**SUBARU****QUALITY DRIVEN® SERVICE****SERVICE BULLETIN****APPLICABILITY:** 2017MY Forester Models with EyeSight**NUMBER:** 04-18-17**SUBJECT:** DTC B281C for EyeSight System**DATE:** 08/15/17**INTRODUCTION:**

This bulletin announces availability of a new Electronic Power Steering (EPS) controller to address a very limited number of cases involving DTC B281C “INCOMPATIBLE WITH EYESIGHT (EPS)” in the EyeSight system.

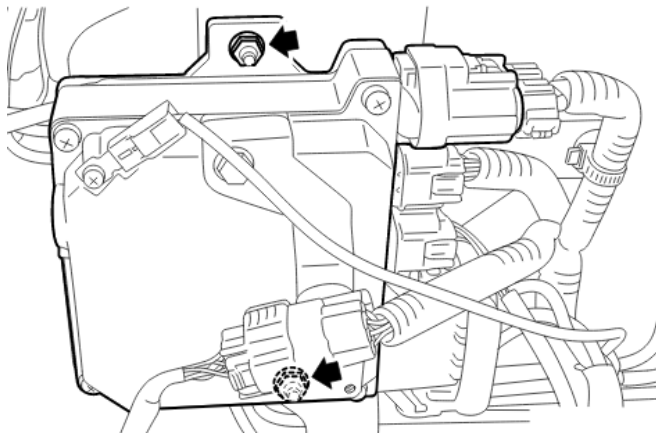
The new EPS controller was incorporated into production starting with VIN **H*549728**.

The part number for the new CONTROLLER-STEERING is: **34710SG101**.

- If the EyeSight system warning light illuminates, check for any stored DTC using SSM-4.
- If DTC B281C is in memory, replace the EPS controller following the procedure in the applicable Service Manual.
- If B281C is not stored, follow the EyeSight diagnostic procedures in the applicable Service Manual.
